INCH-POUNDMIL-B-81935/5B
AMENDMENT 1
19 April 1991

MILITARY SPECIFICATION SHEET

BEARING, PLAIN, ROD END, SELF-ALIGNING, SELF-LUBRICATING,
NARROW, INTERNALLY THREADED, -65°F to +325°F

This amendment forms a part of MIL-B-81935/5B, dated 1 June 1987 and is approved for use by all Departments and Agencies of the Department of Defense.

Example:

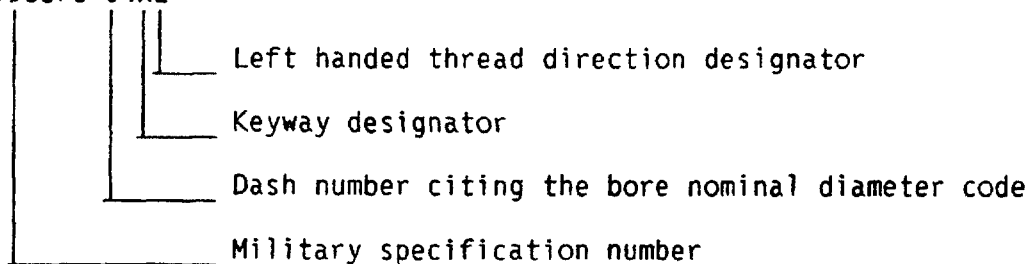
Under the heading "Part number," delete and substitute the following:

"Part number: The part number consists of the letter M, the basic number of this specification sheet, followed by a two digit dash number from table I, followed by an alpha code letter 'K' for a keyway or 'W' for a deep square slot keyway (no code when a keyway is not desired) and an alpha code letter 'L' to designate a left handed thread (no 'L' code would designate right handed threads)

M81935/5-04WL
